RE: (Planning Application No. A/SK-CWBS/42) Request for Further Information
08/09/2022 15:09

2. This application is for low voltage -380V installation related with proposed poles and underground cables
3. According to the application form, the proposed electricity installation will connect to a meter box. This meter box position is under another approved planning application No. A/SK-CWBS/36.

Figure 3. Example of the plastic fencing

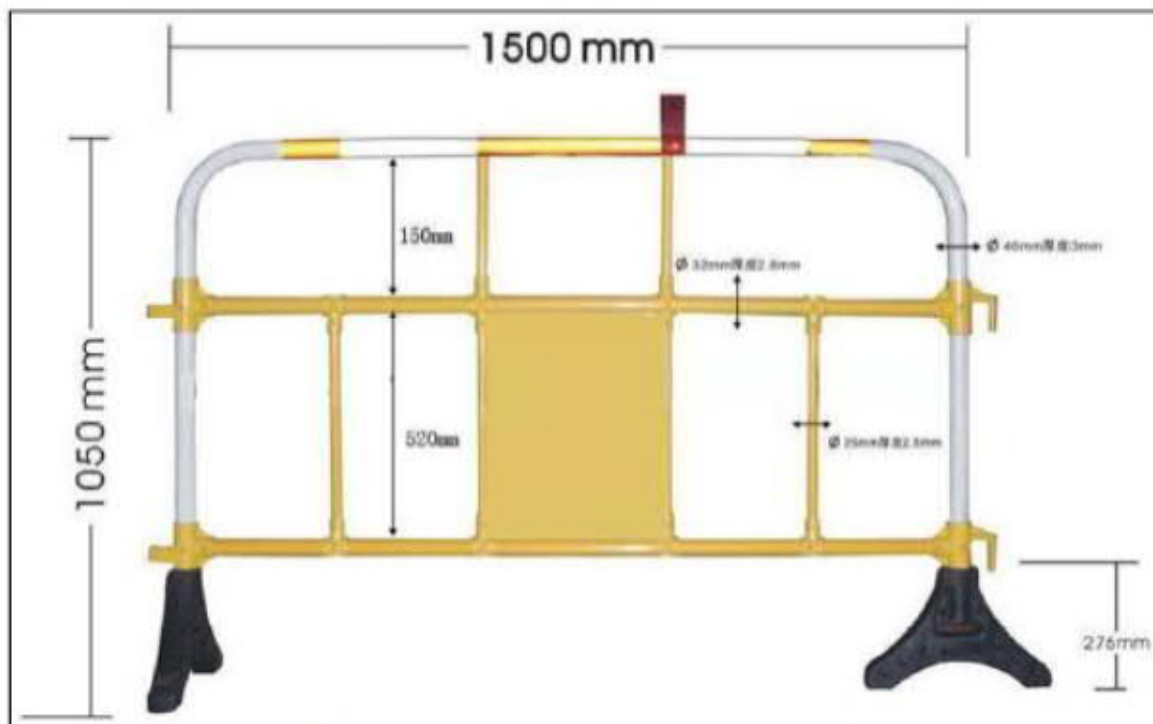
8. To protect the trees, tree protection zone fencing would be installed around the agreed perimeter of the Tree Protection Zone (TPZ). Fencing should be sturdy and highly visible to discourage entrance and disturbance of the area within the TPZ. (details referred to the Figure 3 below).

9. Moreover, All sections of fencing should be clearly marked with signs stating that the area within is a Tree Protection Zone and that no one is allowed to enter this area except the authorized person (details referred to the Figure 5 below).
